EXISTING FACILITY PRELIMINARY ASSESSMENT REPORT

Waterside at Flathead Lake Condominiums
7175 U.S. 93 South
Lakeside, Montana 59922

Report Date: October 16, 2023

Reported By: Studio Obermeier Sheykhnet Architecture
New Rome Engineering et. Al.

SKA • 604

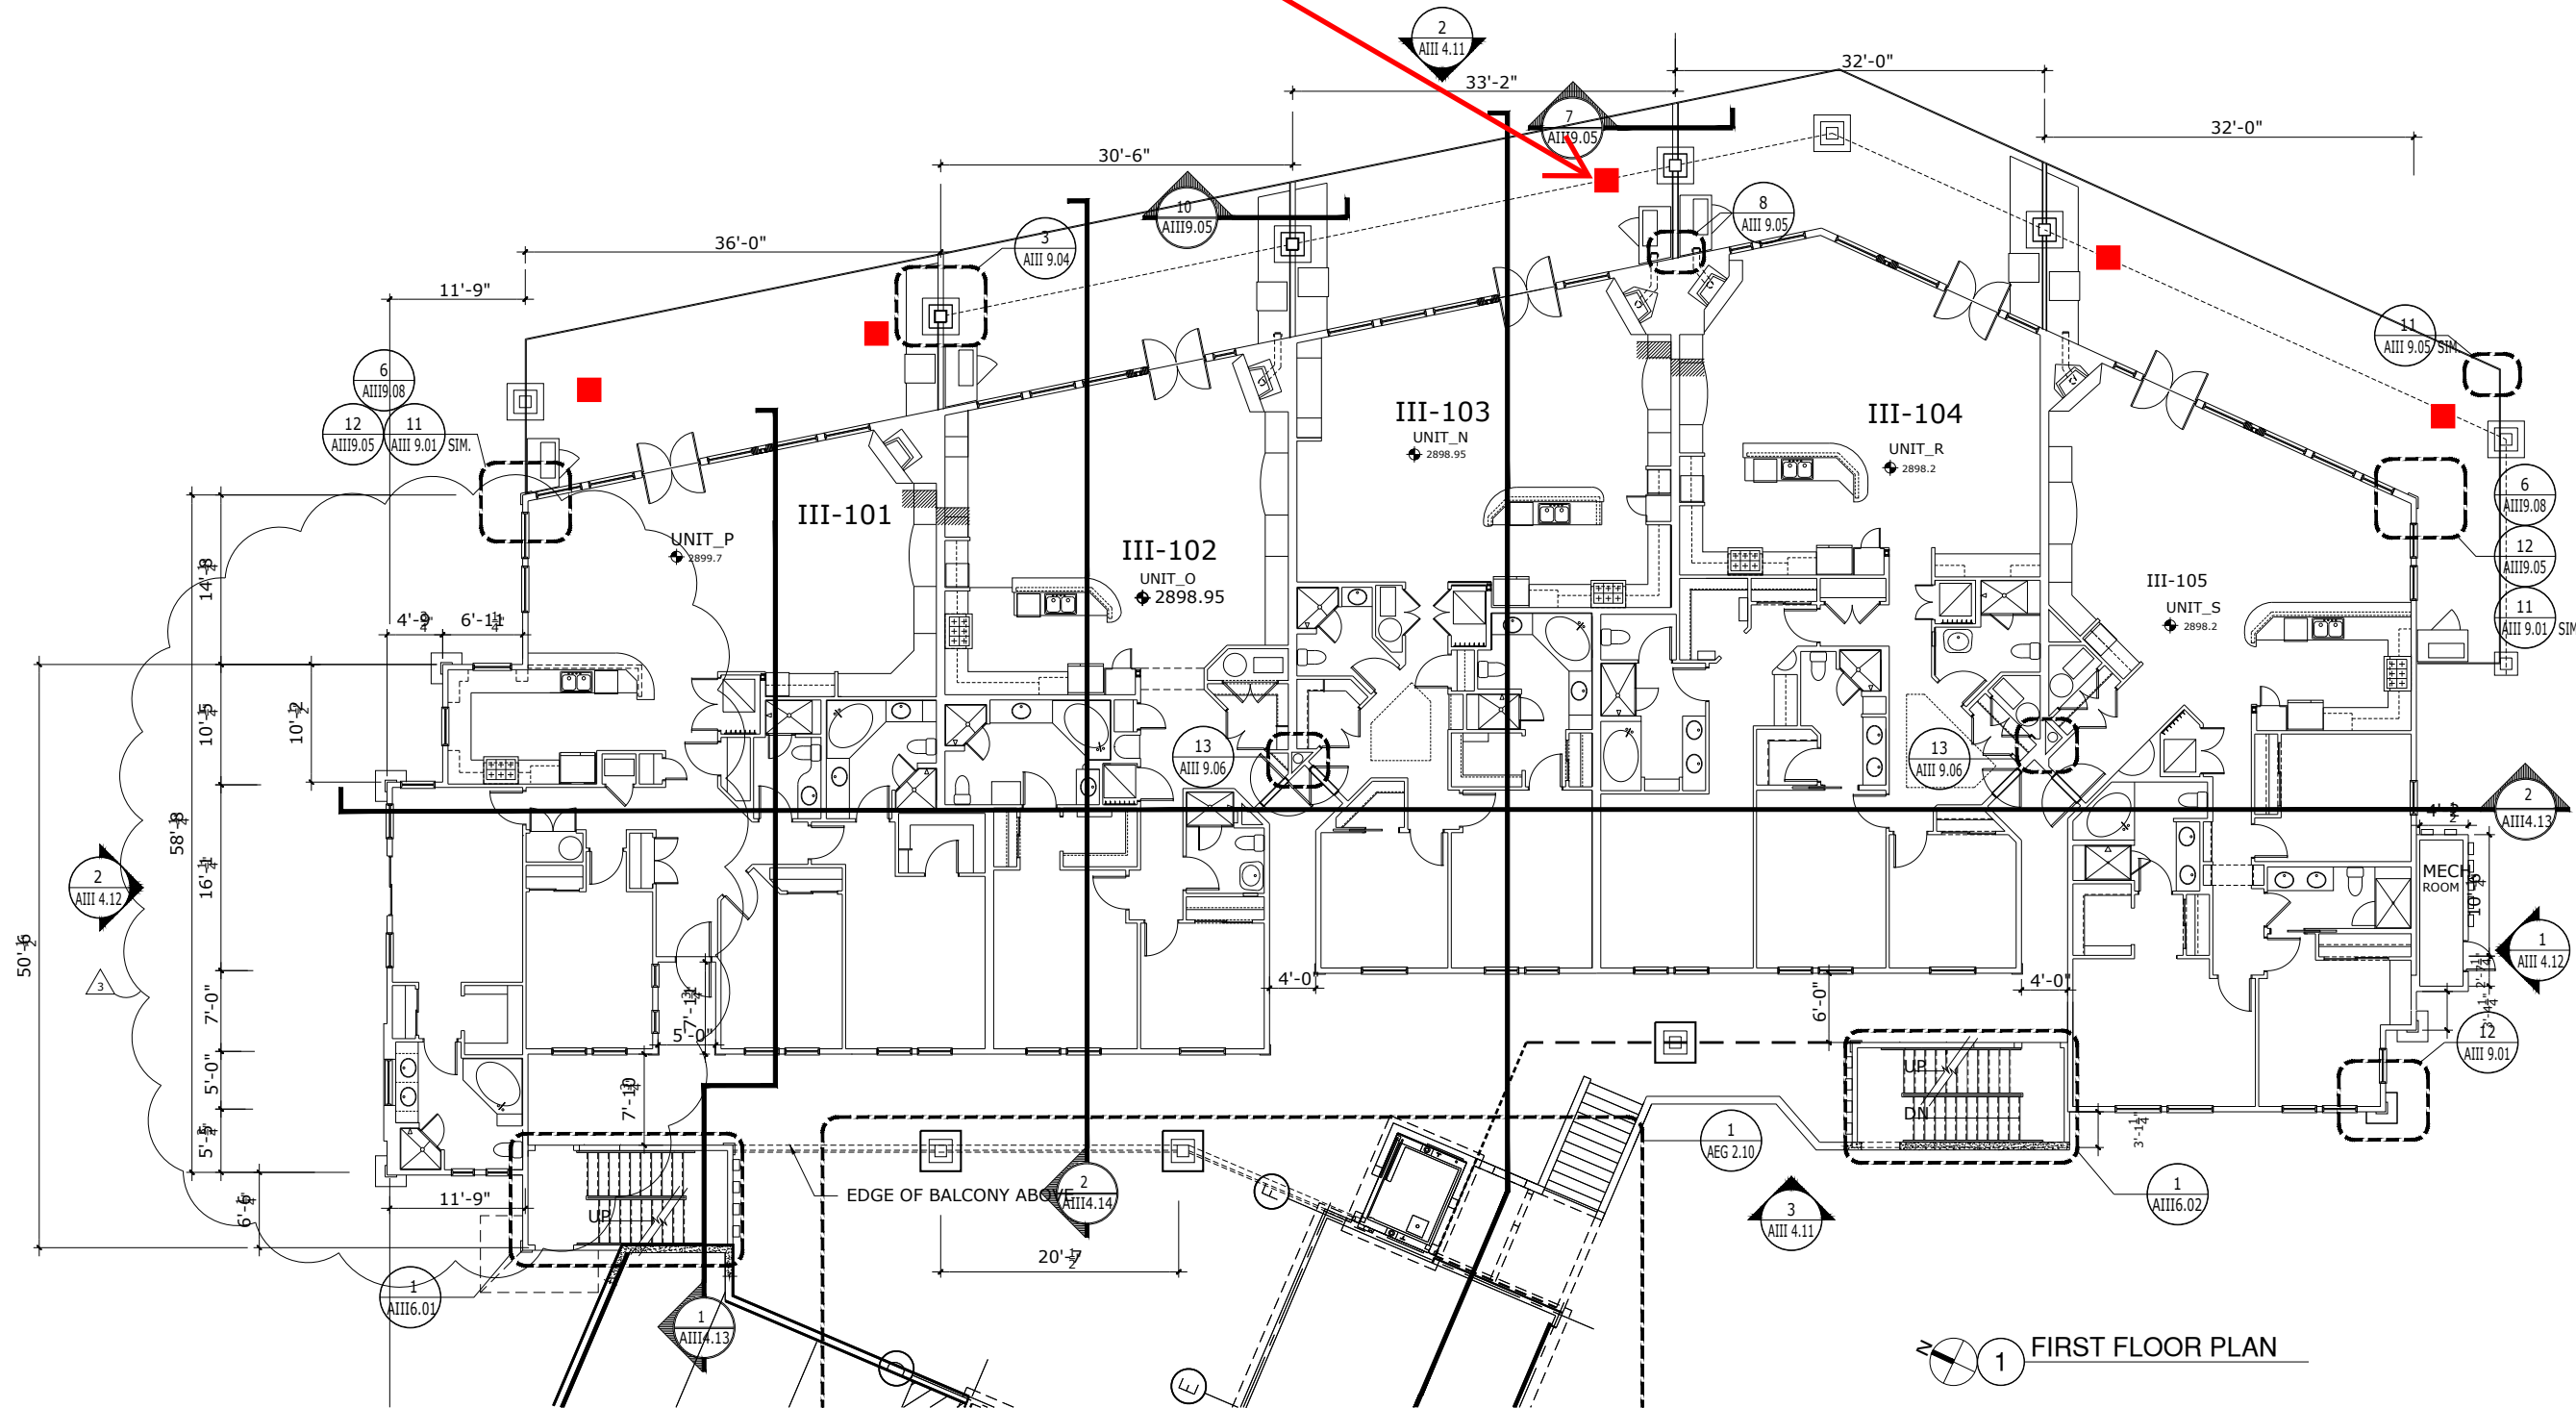
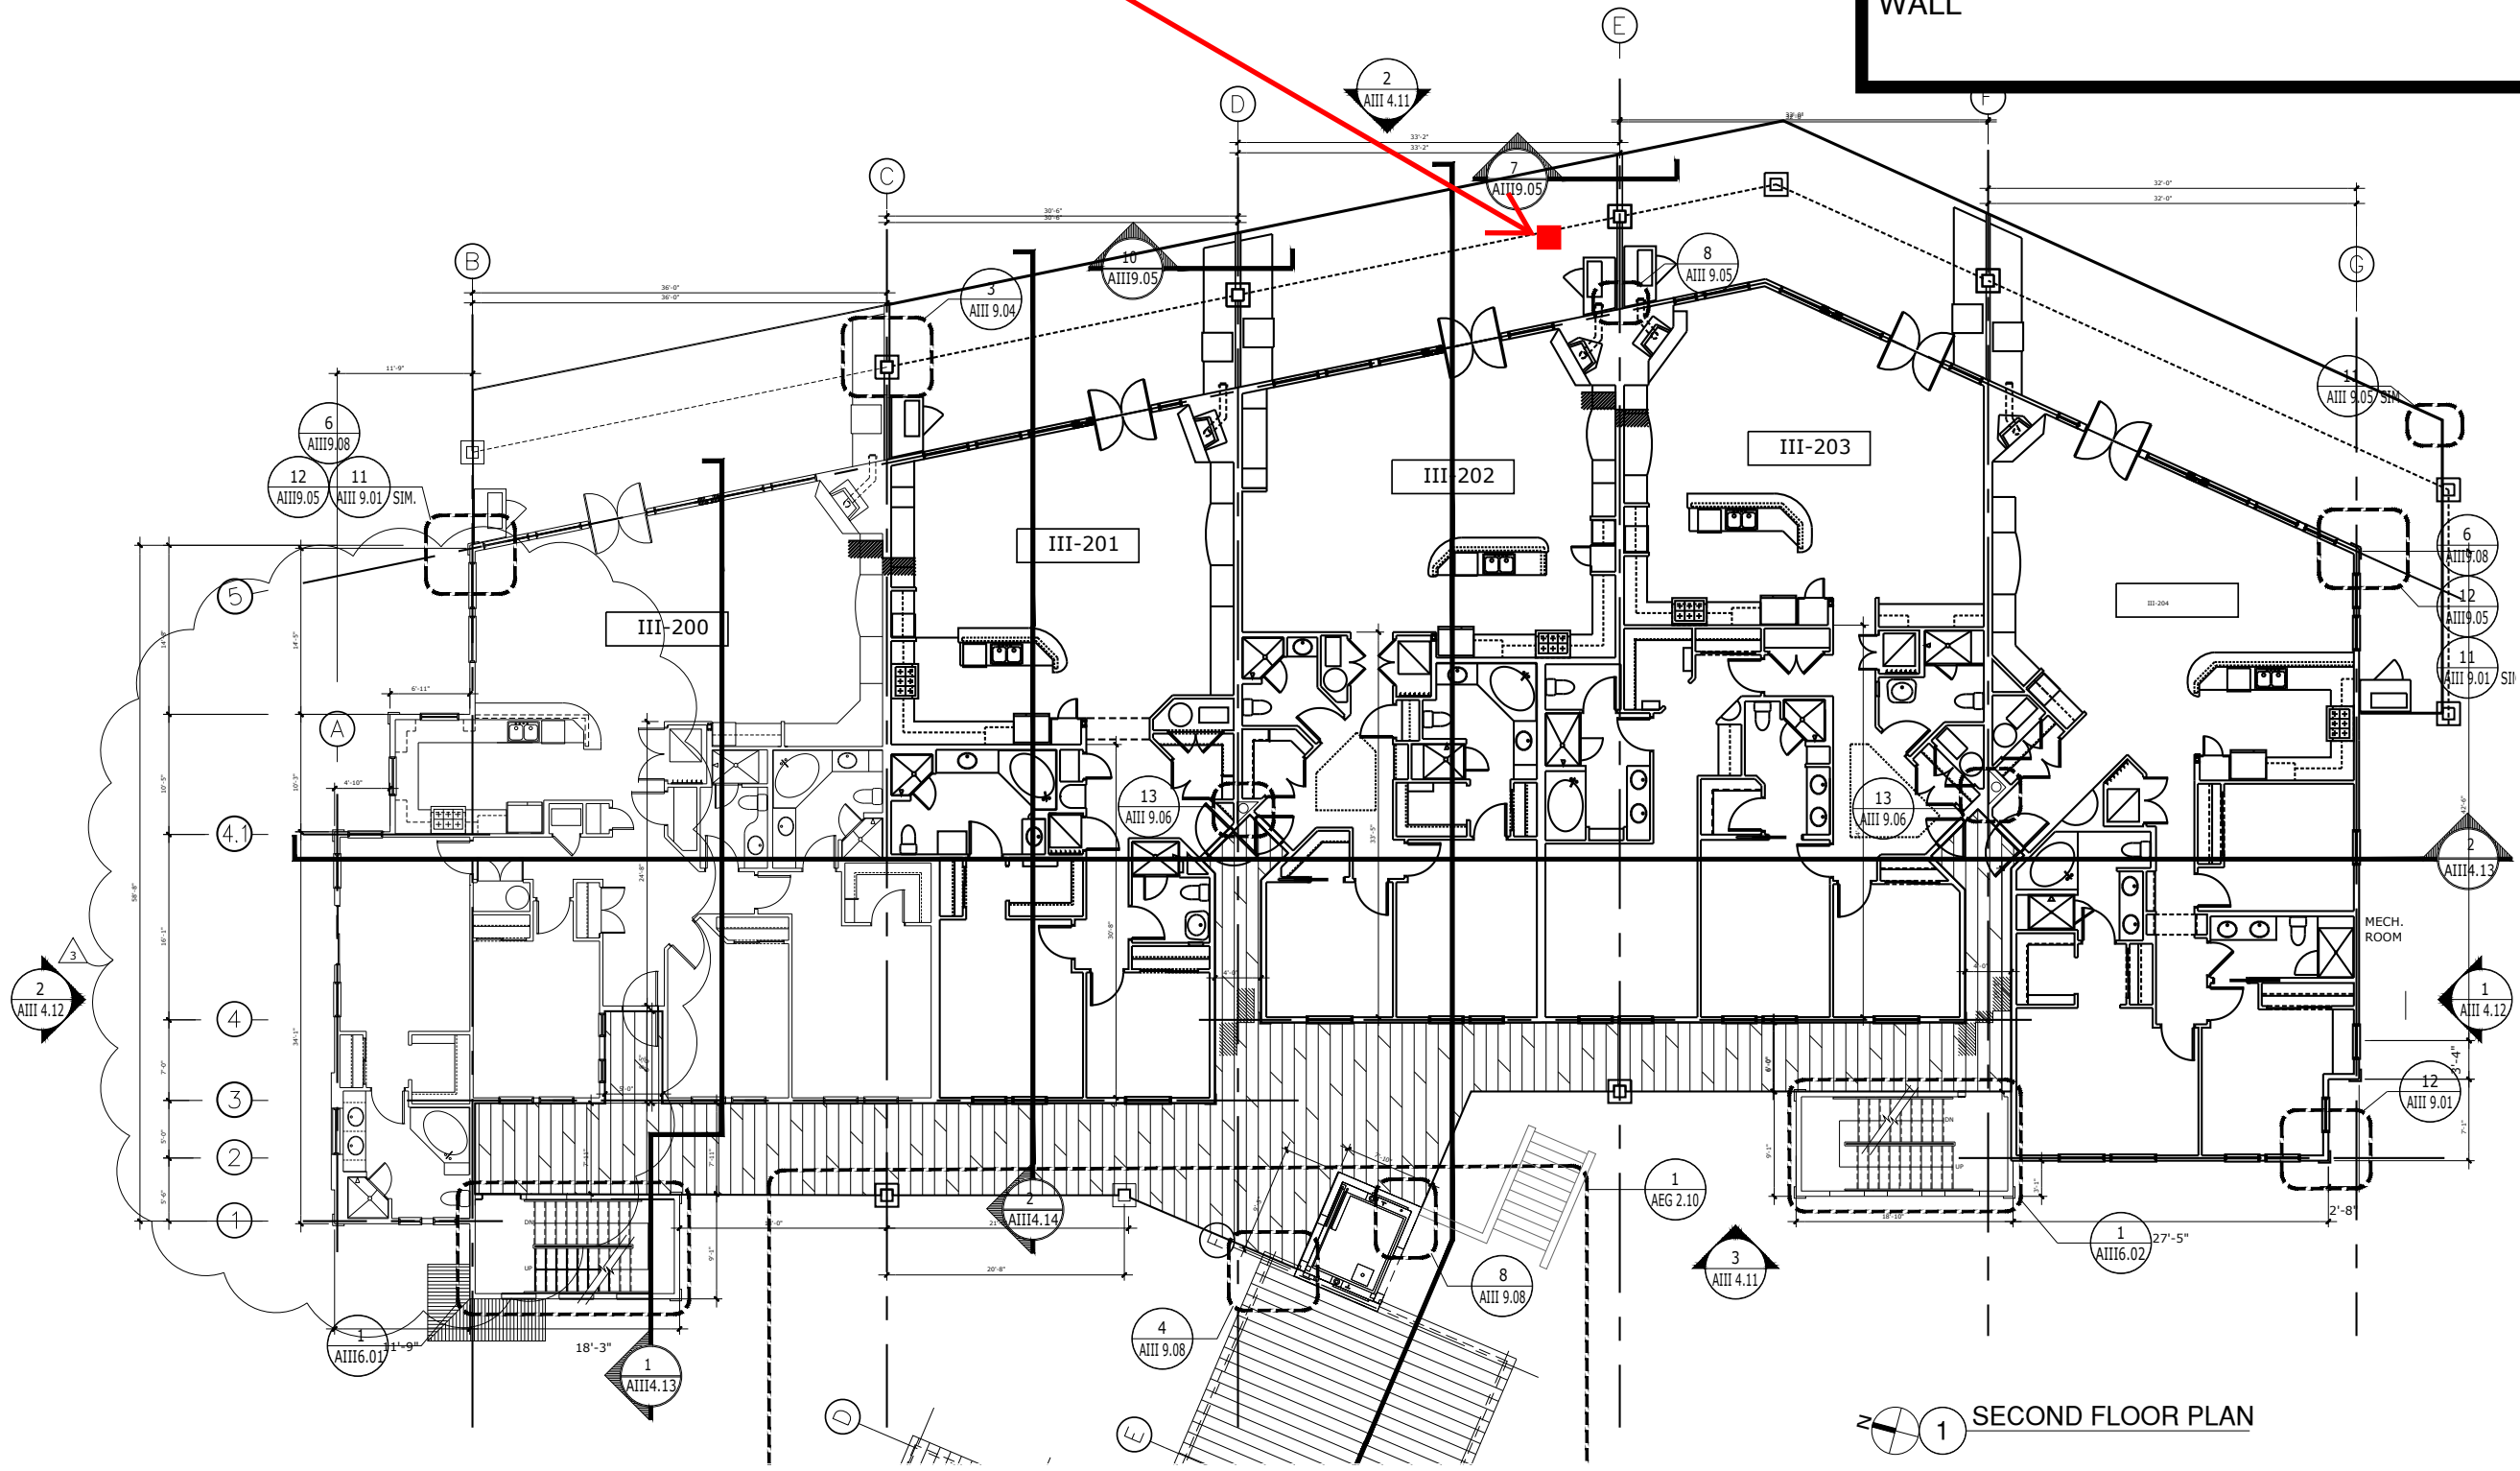
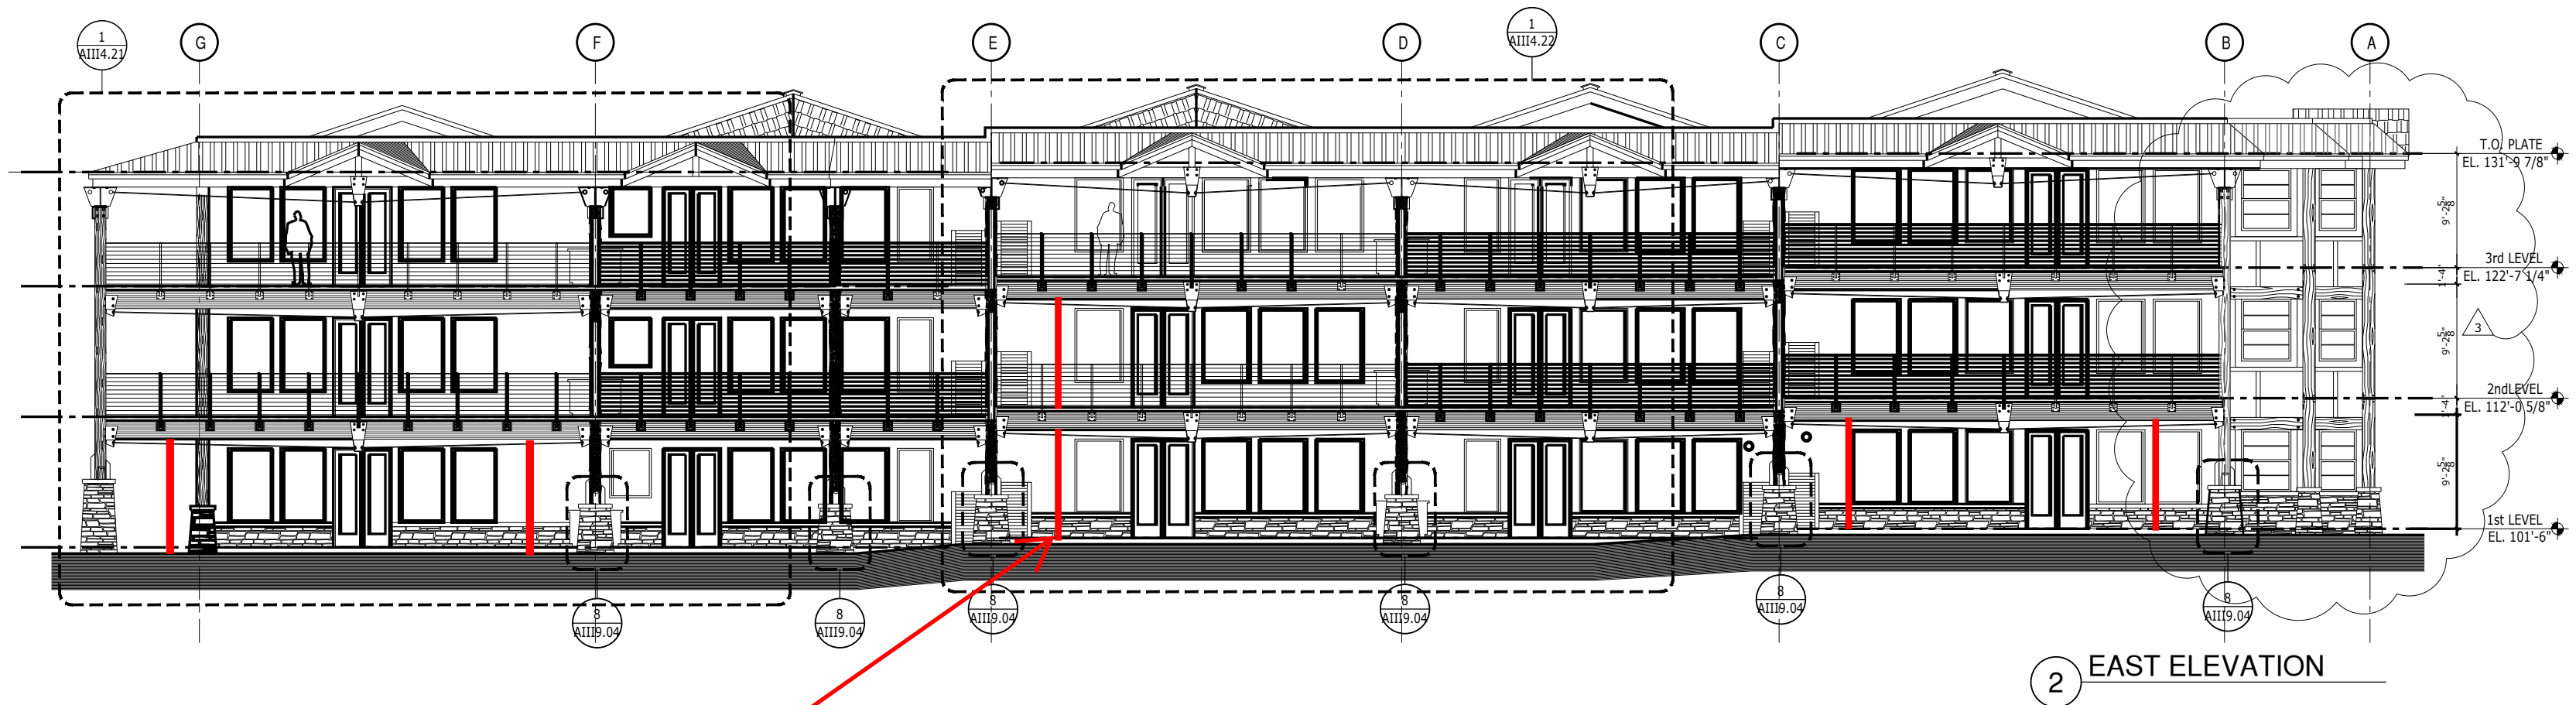
Adjustable Schedule 40 steel columns to be installed approximately 4' to 5' from each end of existing exterior beam line to provide temporary bracing to failing perimeter beams.

1. (2) at DU# 101 North & South ends
2. (1) at DU# 103 South end
3. (1) at DU# 203 South end directly above temporary bracing at DU# 103
4. (2) at DU# 105 North & South ends in lieu of framed bracing wall
